GOVERNMENT OF THE DISTRICT OF COLUMBIA  
DEPARTMENT OF TRANSPORTATION

**MEMORANDUM**

**SUBJECT:** ZC Case No. 02-38 I – 375 & 425 M Street SW (Waterfront Station)

Figure 1 – Site Circulation Diagram (Source: Perkins Eastman DC, Plan Set, Page 10, 3/16/18)

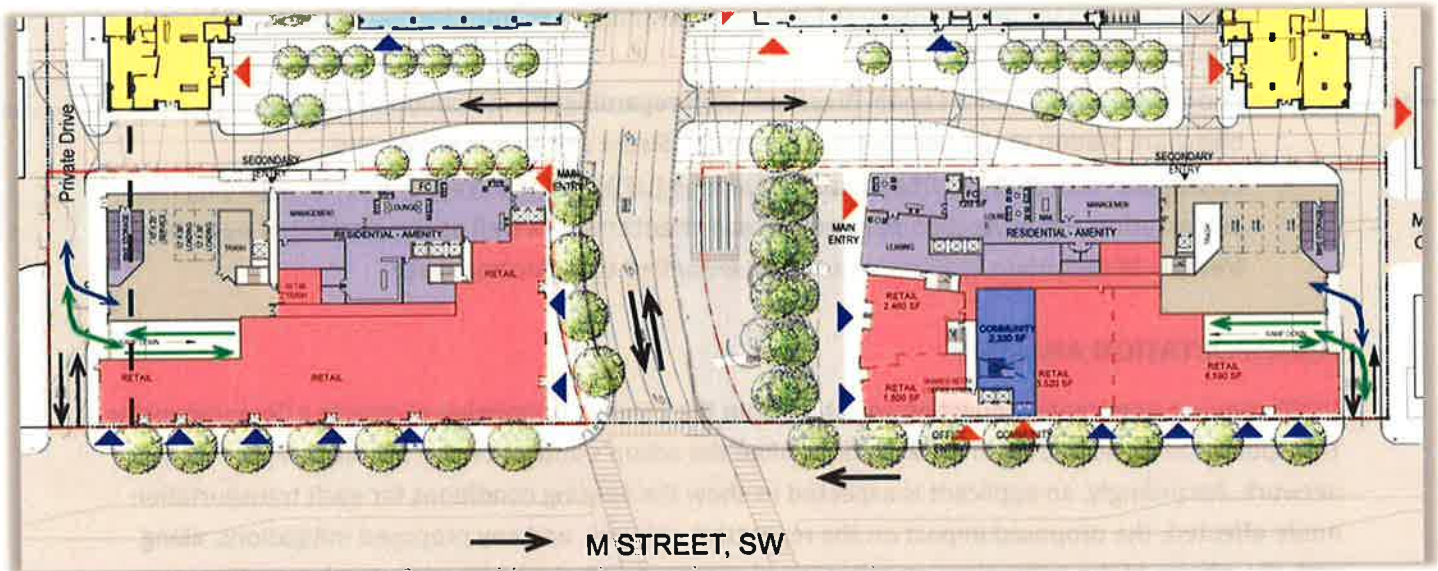
DDOT’s practice is to accommodate vehicle loading in a safe and efficient manner, while at the same time preserving safety across non-vehicle modes and limiting any hindrance to traffic operations. For new developments, DDOT requires that loading take place in private space and that no back-up maneuvers occur in the public realm.

delivery space. For the retail component of this project (under 20,000 SF at each building), zoning requires one (1) loading berth, one (1) loading platform, and zero (0) delivery spaces. The Applicant is proposing to meet these requirements by providing two (2) 30-foot loading berths with platforms and one (1) 20-foot delivery space at each of the east and west buildings. Access to the loading areas of each building will be via the rear private driveway. All truck turning maneuvers will occur on private property and all movements to and from the public transportation network will occur head-in and head-out. DDOT is in concurrence with the proposed loading scheme as shown in Figure 1 above.

Figure 2 – Public Plaza Concept (Source: CTR, Gorove/Slade, Figure 12, 10/17/17)

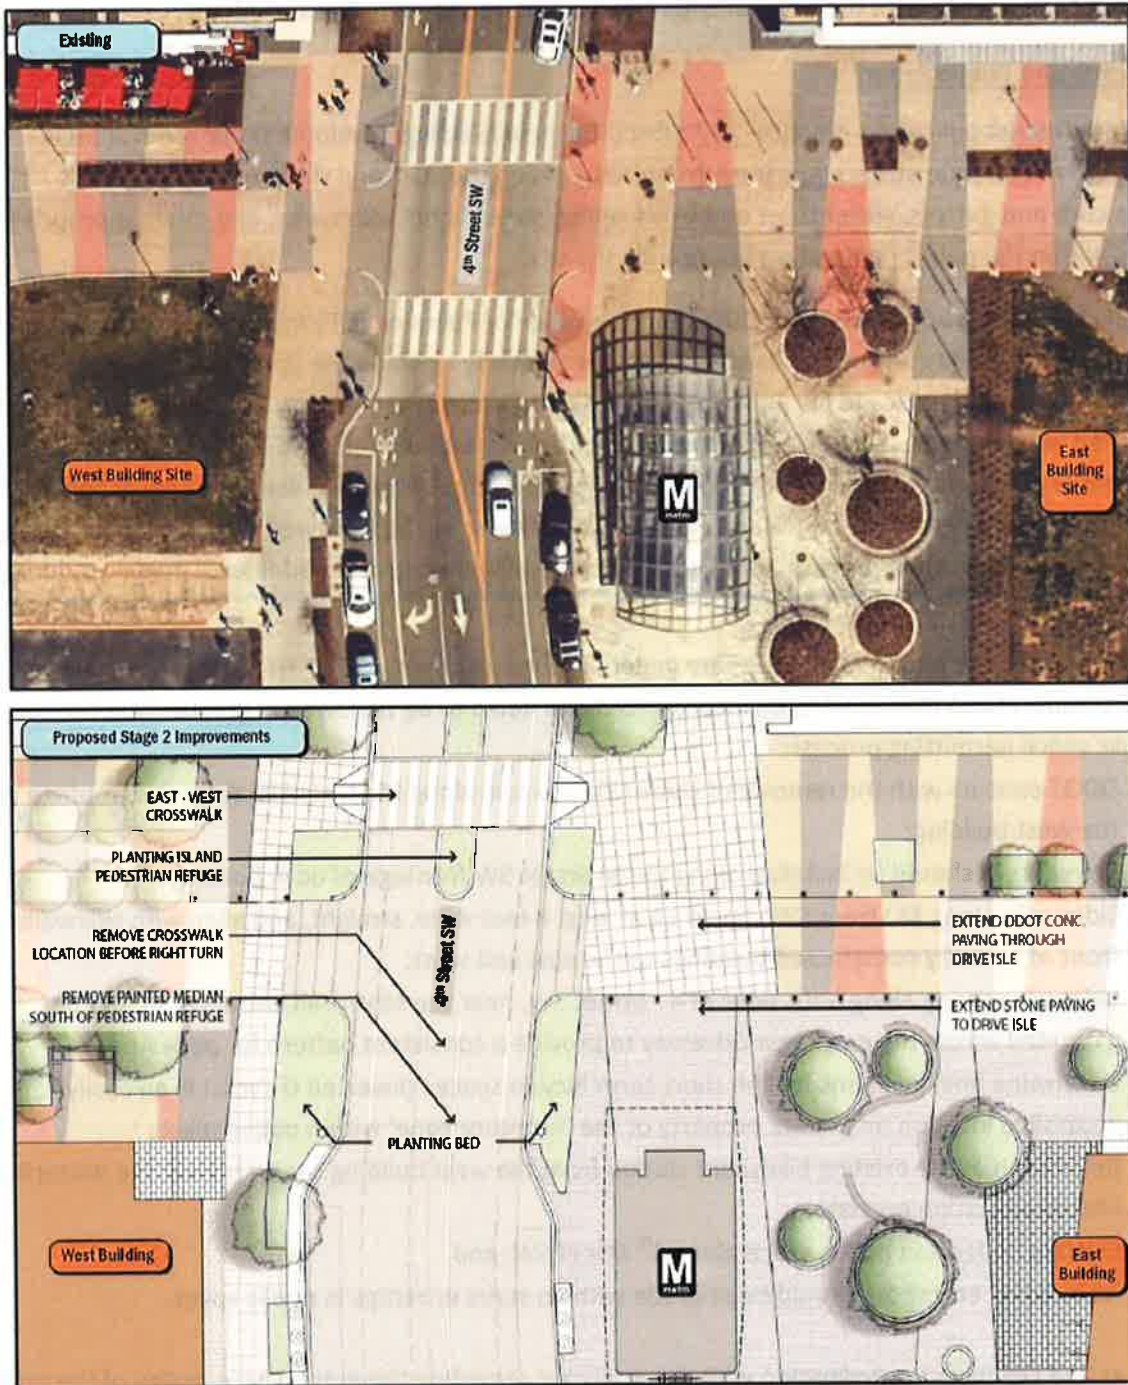
DDOT has had significant coordination with the Applicant regarding the public space design of the public plaza surrounding the Metrorail entrance and operational changes within 4<sup>th</sup> Street SW. DDOT generally

finds the Applicant's proposal, in Figure 2 below, to be acceptable. However, it is noted that these plans should be part of the public space application package and any changes within the roadway (e.g., removal of crosswalk, installation of pedestrian refuge) are subject to DDOT approval.

Figure 10 – Existing Pedestrian Infrastructure (Source: CTR, Gorve/Slade, Figure 30, 10/17/17)

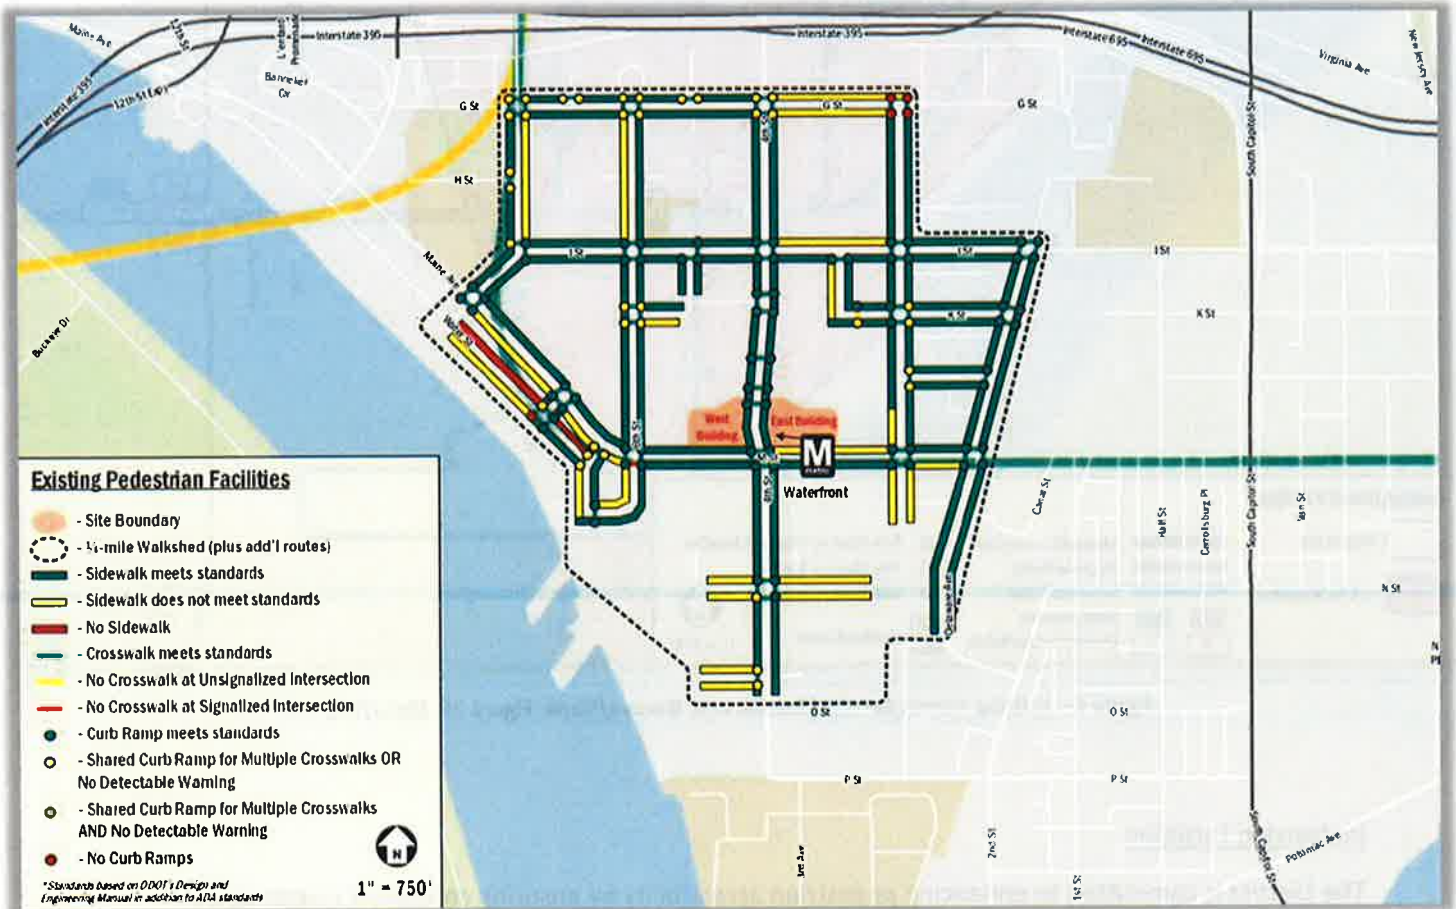
The CTR’s inventory of existing pedestrian infrastructure, as shown in Figure 10 below, demonstrates that most sidewalks and curb ramps in the vicinity of the site are currently consistent with DDOT standards. While there are a few missing or substandard segments of sidewalk and curb ramps in the broader area, the existing pedestrian network along major pathways to schools, attractions, and the Metrorail station is generally adequate. The existing sidewalk along the northern side of M Street currently has a substandard width for the future mix of land uses proposed. The sidewalk should be reconstructed at least 8 feet wide and align with the sidewalks recently constructed with the buildings to the east and west. Additionally, DDOT understands that following recent discussions between the

Applicant and community, sidewalks are now proposed along the east side of the western private drive and the west side of the eastern private drive. These should be clearly shown on the plan set.

It is noted that the upgrading of missing pedestrian facilities and removal of the southbound channelized right-turn lane at Maine Avenue and 6<sup>th</sup> Street SW, west of the site, will occur in conjunction with the Wharf Phase 2 development.

Figure 11 – Signage, Striping and Traffic Calming (Source: Transportation Memo, Gorove/Slade, Figure 3, 3/16/18)

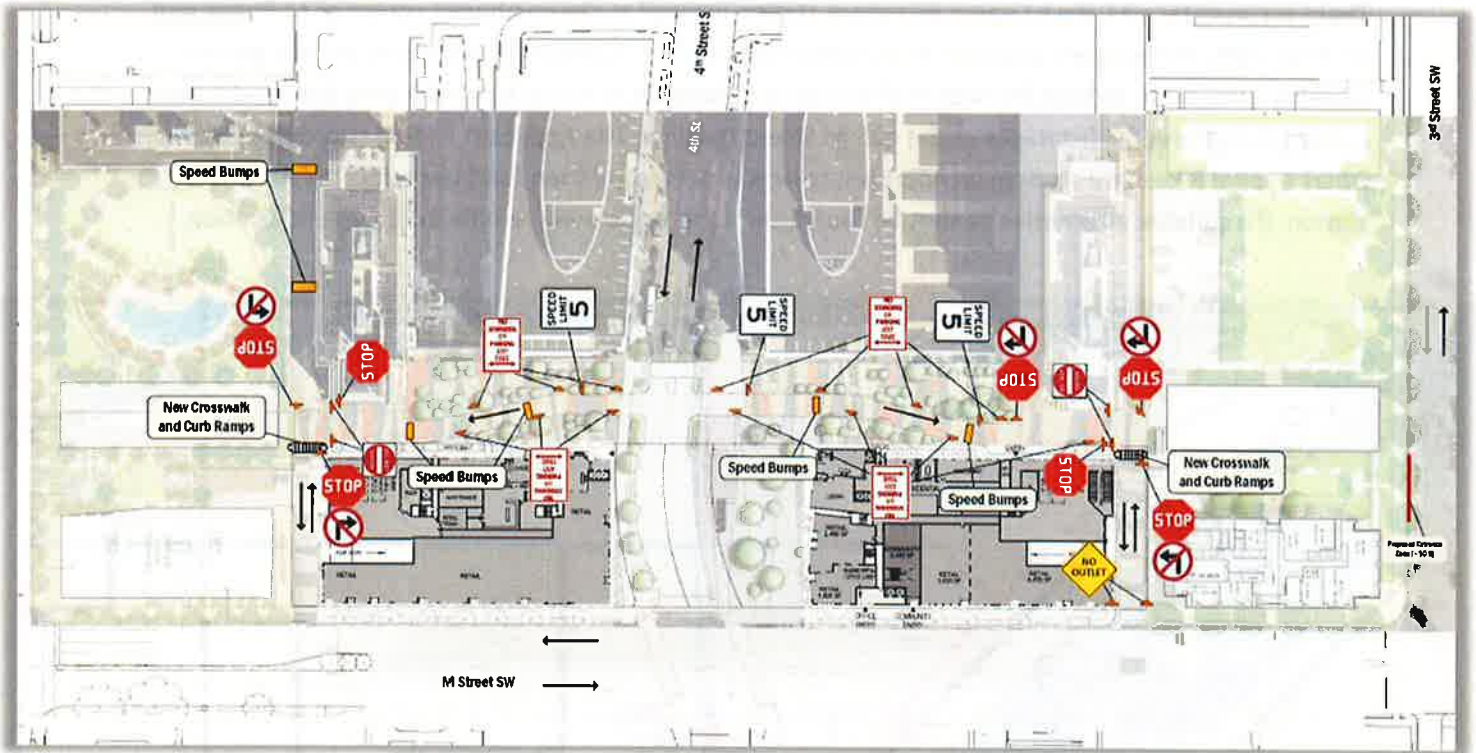
- The Applicant should implement the signage, striping, and traffic calming improvements on the private drives, as proposed in the March 16, 2018 supplemental transportation memorandum. DDOT staff is available to assist in the refinement of a final plan, if necessary;

Additionally, the Applicant has proposed a signage, striping, and traffic calming plan for the private drives surrounding both buildings. While not on a public roadway or alley, DDOT generally supports the Applicant's proposal to slow vehicles and prioritize pedestrian safety and connectivity. The Applicant should commit to implementing the improvements shown in Figure 11 below.

Figure 12 – Existing and Proposed Bicycle Facilities (Source: CTR, Gorove/Slade, Figure 31, 10/17/17)

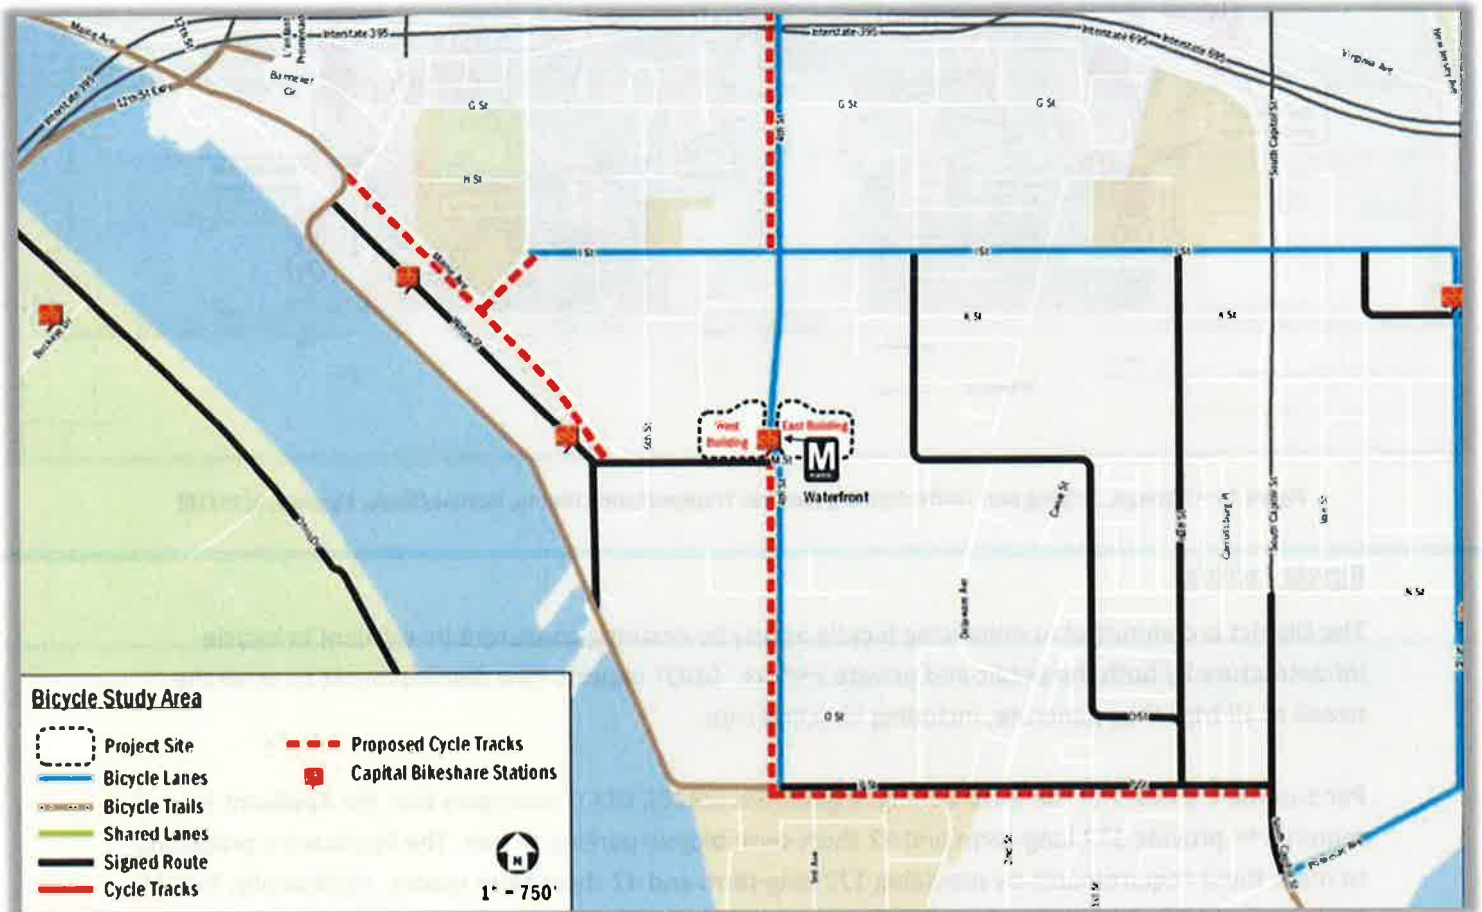
As shown in Figure 12 below, the site is currently in close proximity to bicycle facilities including striped bicycle lanes on both 4<sup>th</sup> Street and I Street SW, as well as portions of cycletrack and the Anacostia Riverwalk Trail to the south and west of the properties.

There is currently a 21-dock Capital Bikeshare station located at the northwest corner of M Street and 4<sup>th</sup> Street SW, immediately adjacent to the west building. The Applicant is proposing to relocate this bikeshare station to behind the Metrorail station overhang so as not to block the proposed pedestrian entrances to the retail frontages at the 425 M Street building. The Applicant should coordinate with DDOT Capital Bikeshare staff on an appropriate new location and then fund the relocation of this station. If a suitable alternative cannot be found, then the station will remain in its current location.
